February 18, 2022

Garvin Design Group
1209 Lincoln St.
Columbia, SC 29201

ADDENDUM NO. 3

PROJECT TITLE
COASTAL CAROLINA UNIVERSITY
LIBRARY LEARNING COMPLEX
 STATE PROJECT NUMBER: H17-9615-MJ
 370 UNIVERSITY BLVD.
 CONWAY, SC 29526

SECTION 1
 SCALE = 3/4" = 1'-0" S4.3

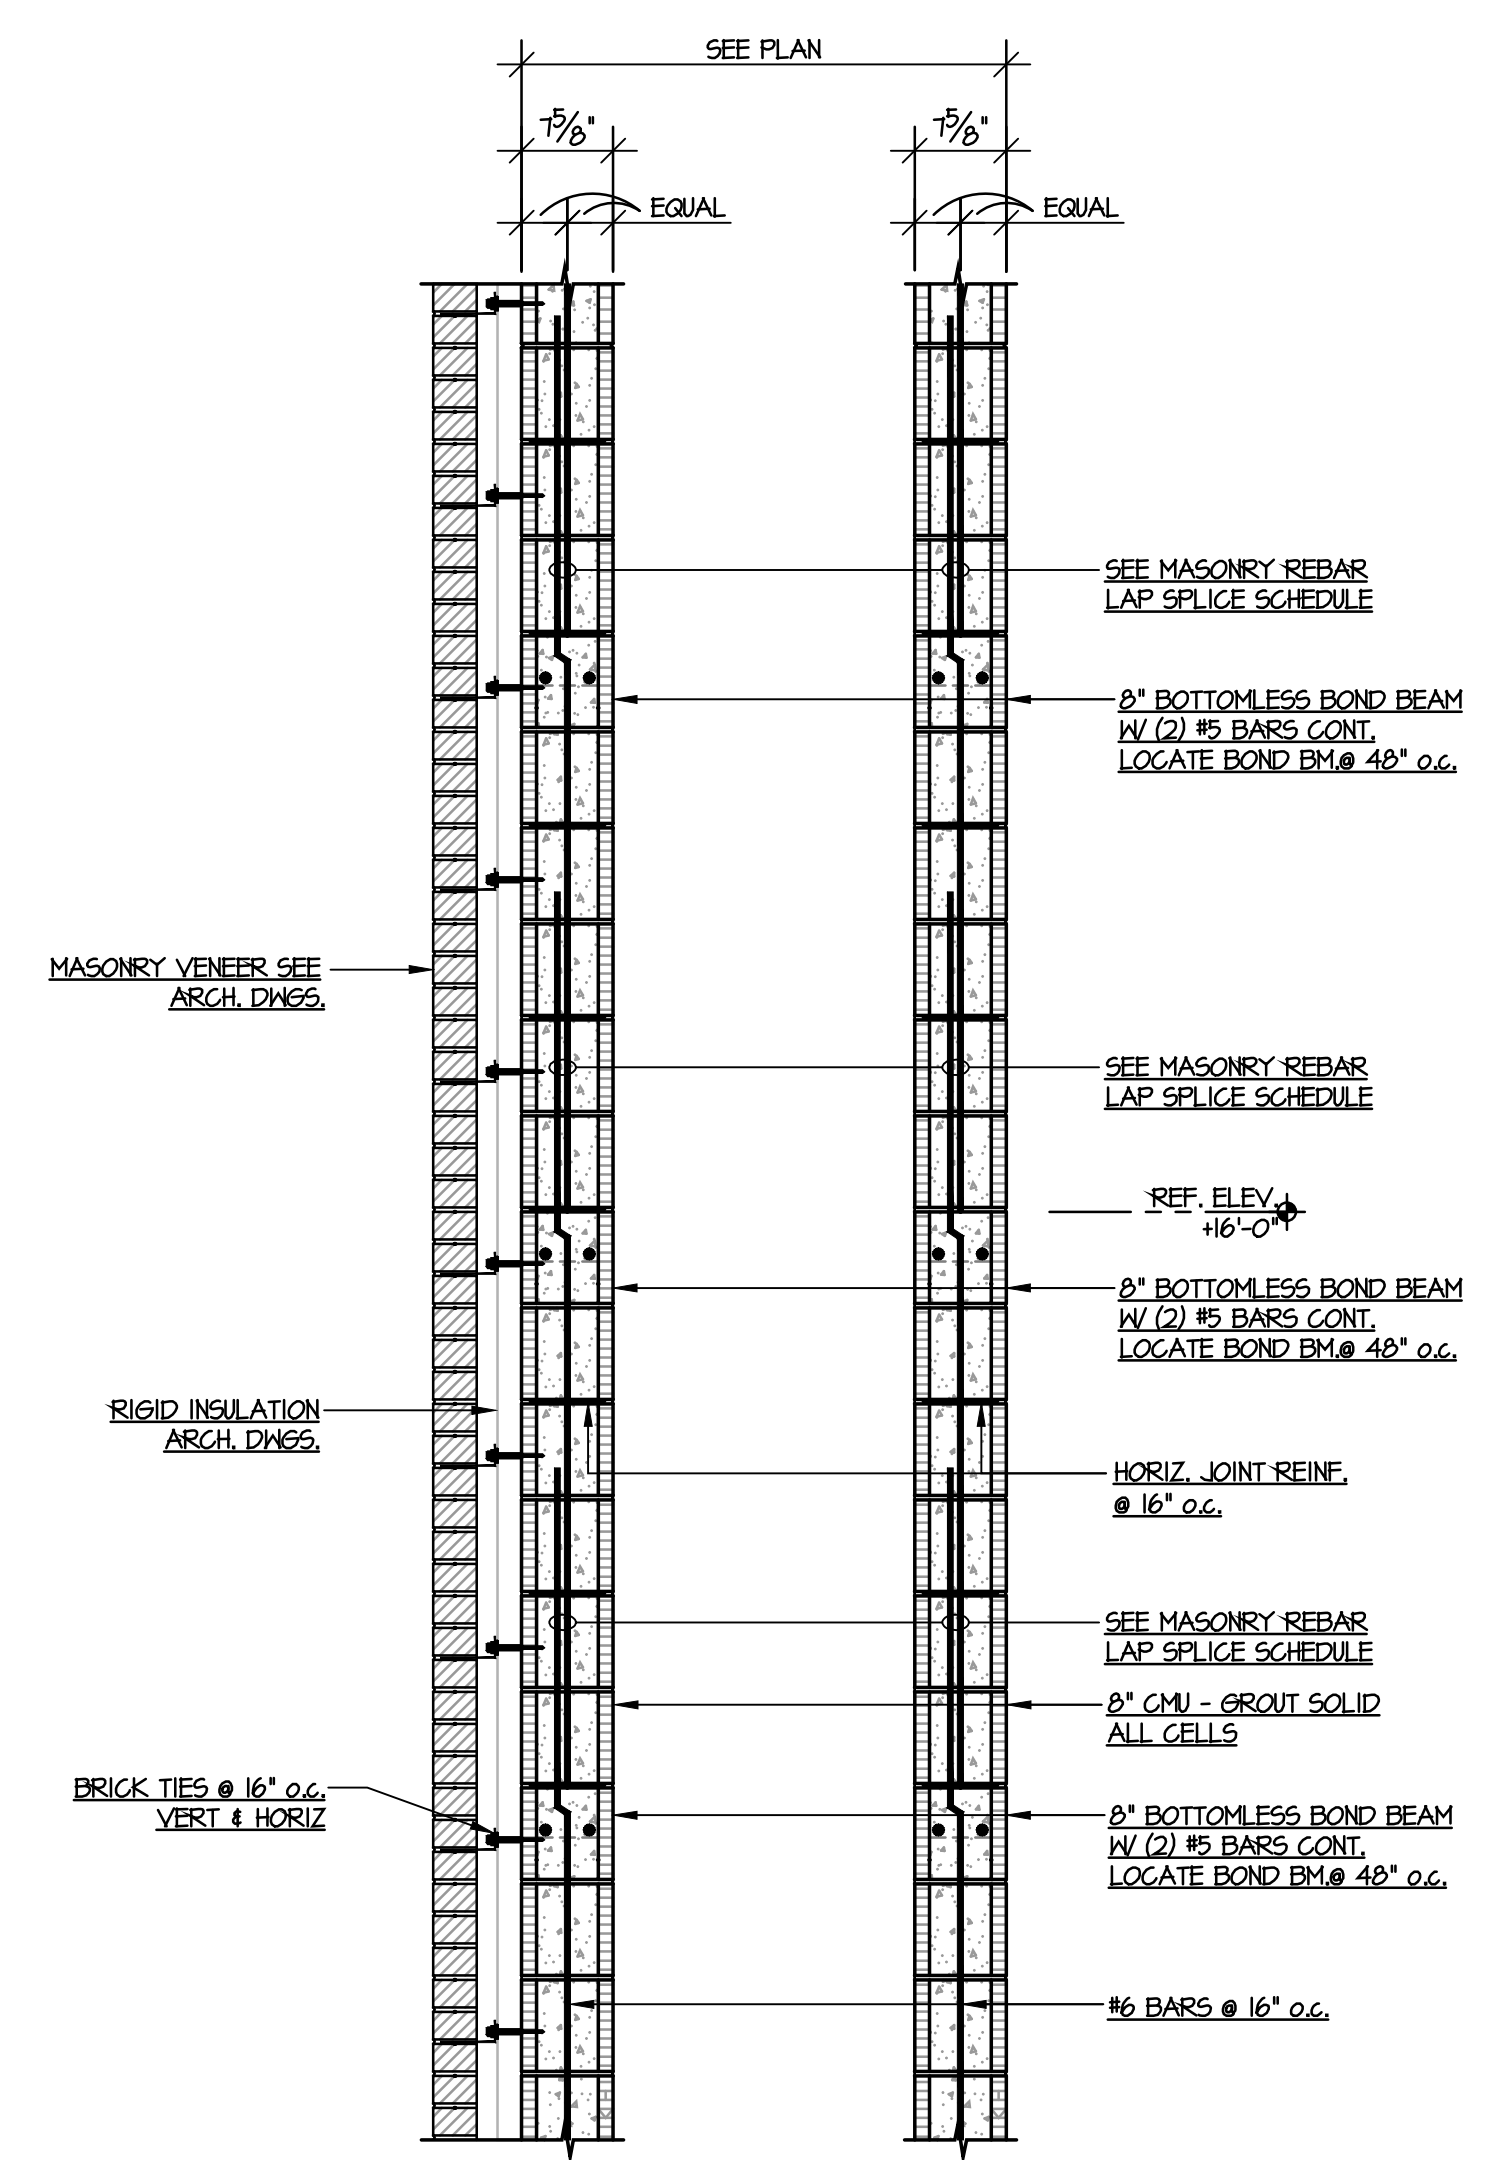
| 3. | <u>Revision:</u> Reference Drawings S4.3 and S4.4 for revised soffit framing details. |

11. Q: Soffit detailing is not similar between structural and Architectural; reference 1/S4.4 and 6/S4.3 and compare against 3/A6.16
A: See revised S4.3 and S4.4 to match soffit framing on 3/A6.16.
12. Q: Structural drawings note 3 mentions sprayed fireproofing; however Table 7 on G1.2 states that the primary structural frame does not required a rating. Confirm no SFRM assemblies are required
A: This general note applies only in the event that there are locations designated with SFRM on structural steel. SFRM assemblies are not required on the project.
13. Q: Section 010000 – 1, 1.4.A. and Bid Form, Page BF-1, 5. – please verify who is responsible for permits, licenses, etc. A: CCU covers the building permit and Chapter 1 and 17 inspections. The Contractor is responsible for all other fees.

SECTION 3
 SCALE = 3/4" = 1'-0" S4.3

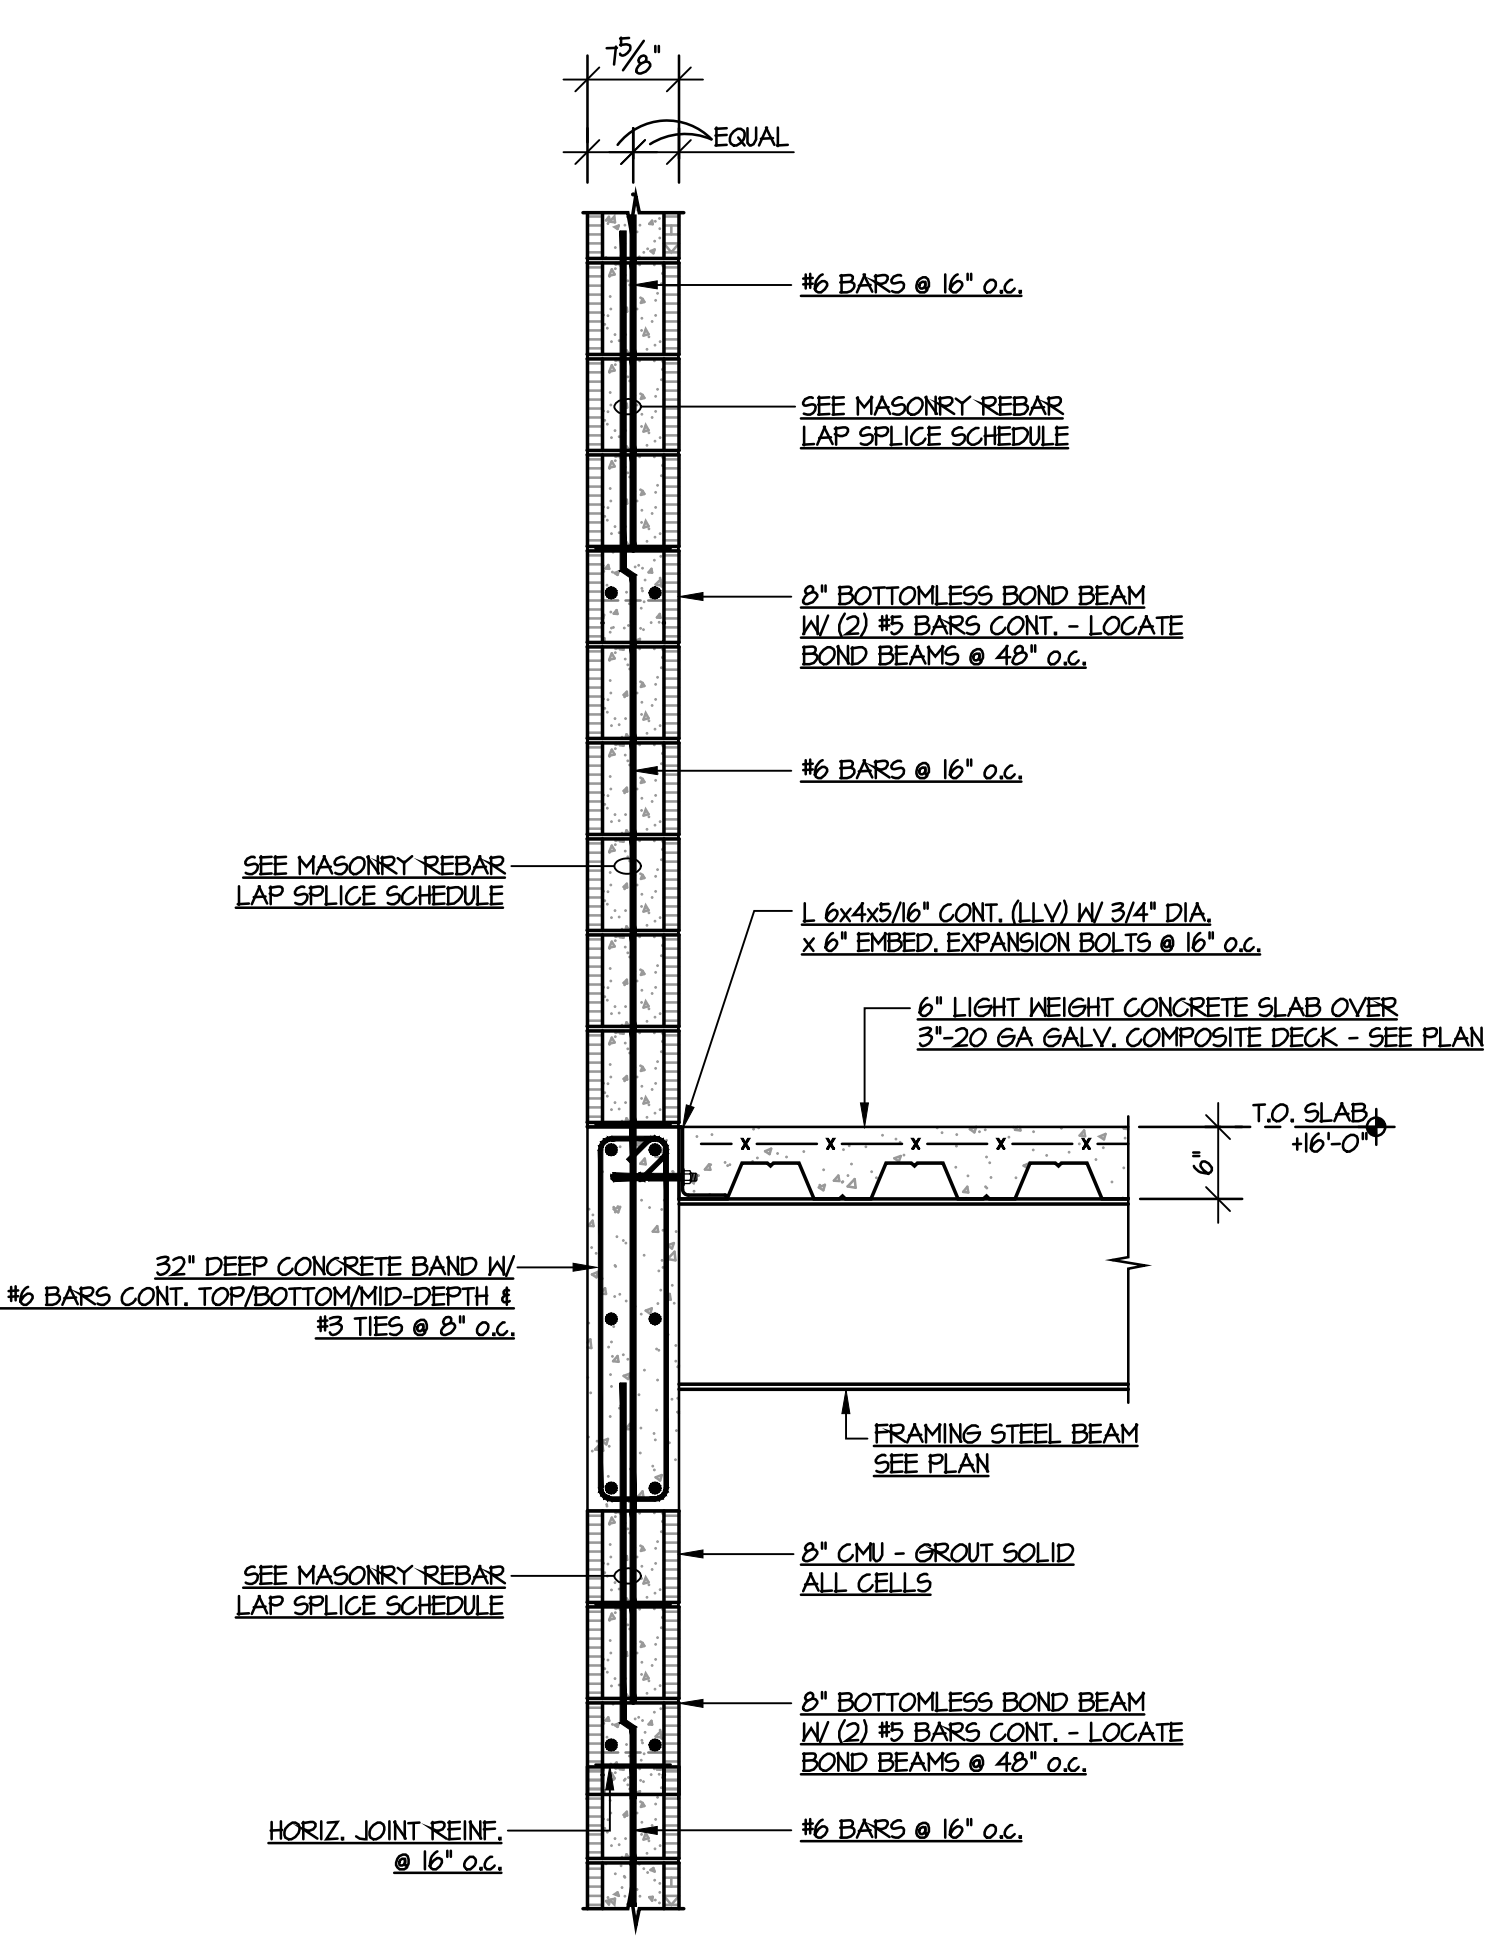
10. Q: Confirm that detail 3/S4.3 is correct for the callout at 8/M on the second floor. Is the 32" deep concrete band required at this location? If so provide extents as indicated by keynote #3.

A: The 32" concrete band is not required at this location.
